Model Series 463 AMG: Active Distance Assist and Active Brake Assist IC Message and DTC U0416FE

Topic number	LI54.71-P-078112
Version	7
Function group	54.71 - Camera and radar-assisted assistance systems
Date	12/11/25
Validity	463 AMG
Reason for change	Line connector part number update

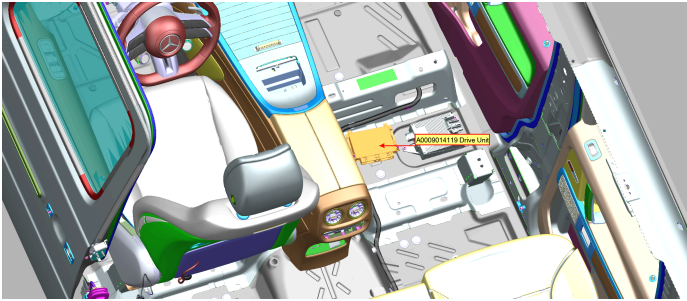
Missing wire between Drive Unit (N145) and Supercap (C8).

- Using a red/white cable with cross-section 0.35 mm² and overall length of approximately 2m.
- Connect Drive Unit (N145) plug A pin 18 to the 3-pin plug of the Supercap (C8) terminal 15 pin 2. Reference the new wire routing location as shown by the red line in "Picture 1 - Connection from Supercap to Drive Unit".
- The new wire should be added to the existing wiring harness as shown by the red line "Picture 1 - Connection from Supercap to Drive Unit".
- Z-Splice is the preferred method using A 000 982 91 10 for the Supercap (C8) connection.

Professionally create a new connection by:
